ACCESSION NBR: 8211090336 DOC. DATE: 82/11/03 NOTARIZED: NO DOCKET #  
 FACIL: 50-438 Bellefonte Nuclear Plant, Unit 1, Tennessee Valley Au 05000438  
 50-439 Bellefonte Nuclear Plant, Unit 2, Tennessee Valley Au 05000439  
 AUTH. NAME AUTHOR AFFILIATION  
 MILLS, L.M. Tennessee Valley Authority  
 RECIP. NAME RECIPIENT AFFILIATION  
 ADENSAM, E. Licensing Branch 4

SUBJECT: Forwards responses to Questions 320.1 & 320.2 in NRC 820903  
 Ltr re production cost analysis & total operating costs.

ENCLOSURE

Graph 320.1-1

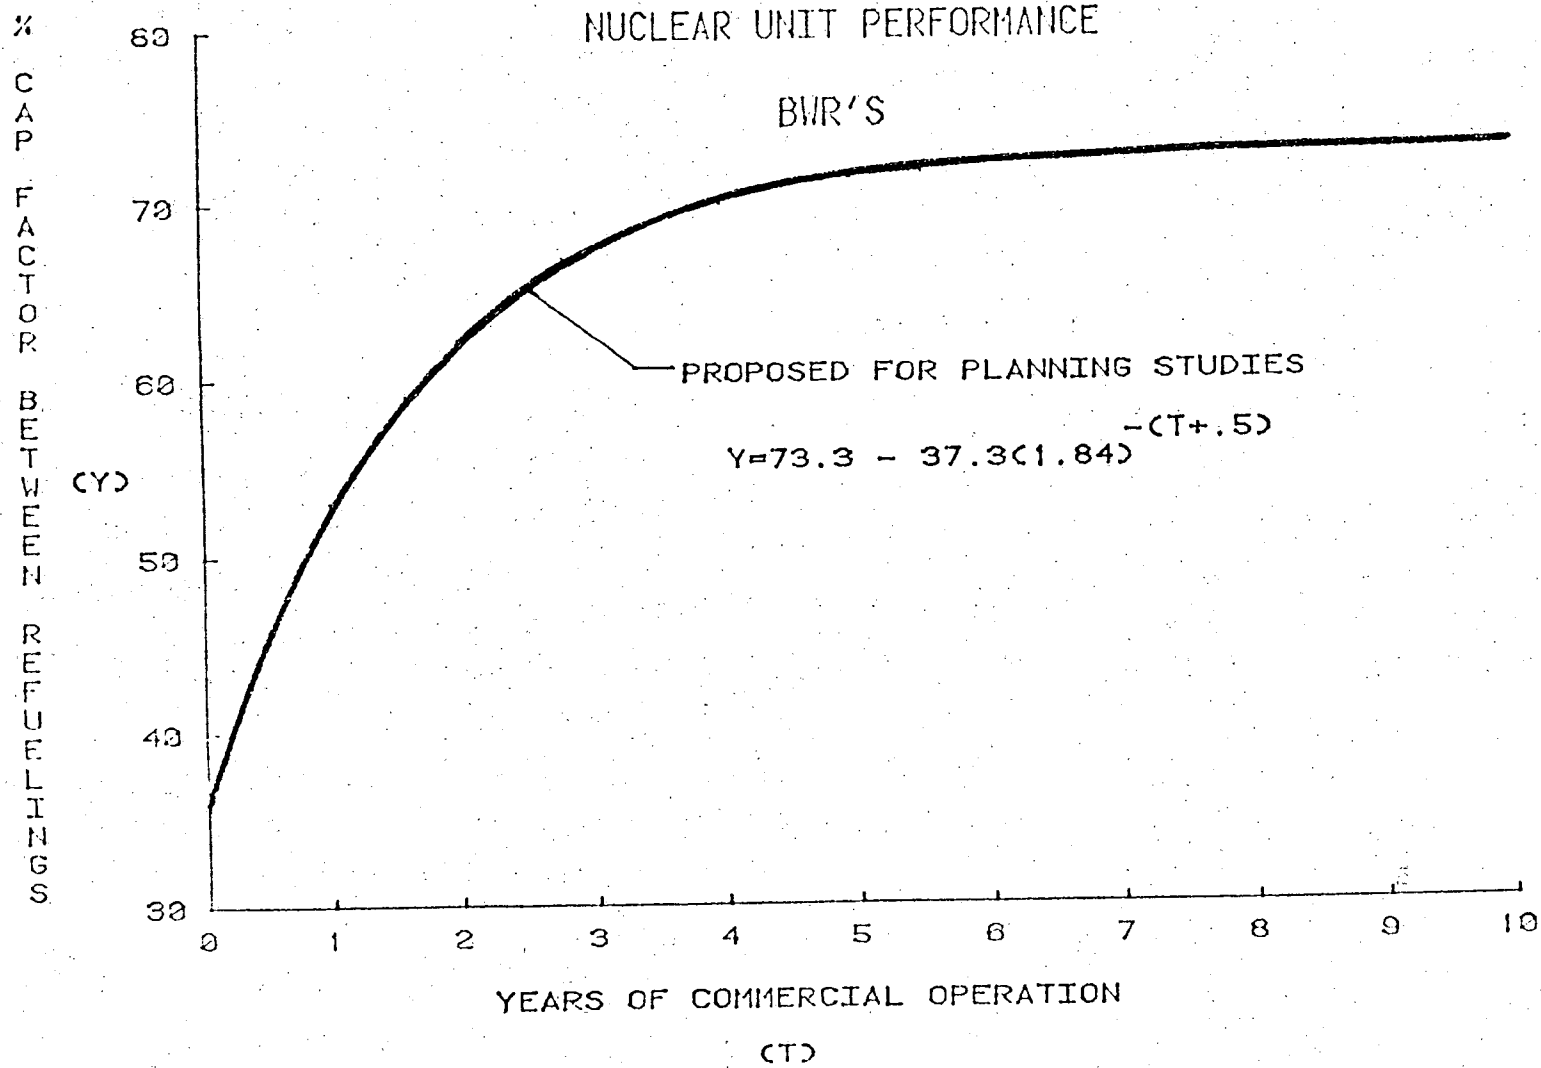
320.1 Question:

A production cost analysis which shows the difference in system production costs associated with the availability vs. unavailability of the proposed nuclear addition. Note, the resulting cost differential should be limited solely to the variable or incremental costs associated with generating electricity from the proposed nuclear addition and the sources of replacement energy. If, in your analysis, other factors influence the cost differential, explain in detail.

The operating level of the nuclear units assumed here, including Bellefonte, are based on industry-wide unit operation. Graphs 320.1-1 and 320.1-2 show nuclear unit performance or maturity curves for boiling water reactor (BWR) and pressurized water reactor (PWR) units, respectively. BWRs should be fully matured in around six years and have an annual capacity factor of 64 percent, including refueling. PWRs, such as Bellefonte, mature similarly and reach a mature annual capacity factor of 61 percent, including refueling.
